BAR Meeting  
March 5, 2014

**ISSUE:** Demolition and New Construction

**APPLICANT:** Carr Hospitality by Rust Orling Architecture

**LOCATION:** 220 South Union Street

Figure 3. Courtyard elevation showing 2a area suggestion for revision. Dashed line indicates the potential continuation of pitched roof with lighter building 2 color.

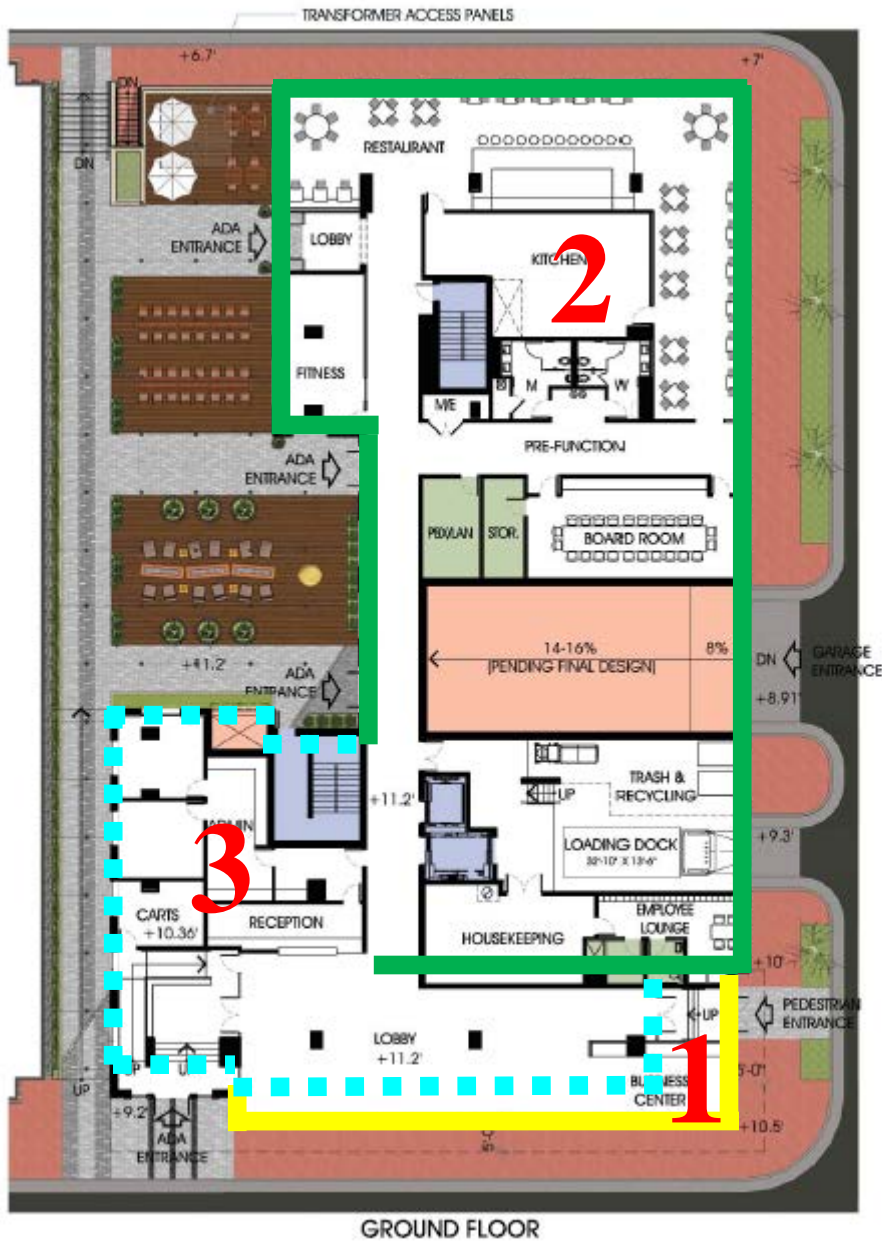
1. That the project read as three distinct but compatible building masses and that the materials, colors and details be standardized for each building. This includes a uniform color scheme, fenestration and architectural details for each “building”; the addition of the gable form on The Strand carried through to the western terminus of that building mass; as well as refinement of the courtyard elevation shown as “2a” in Figure 3.

The courtyard elevations presently show the very dark red brick (B2) color facing north between two tan colored (B1) building masses. The courtyard elevations would have to be restudied to determine where the buff should end and the salmon should begin under the three building scheme.
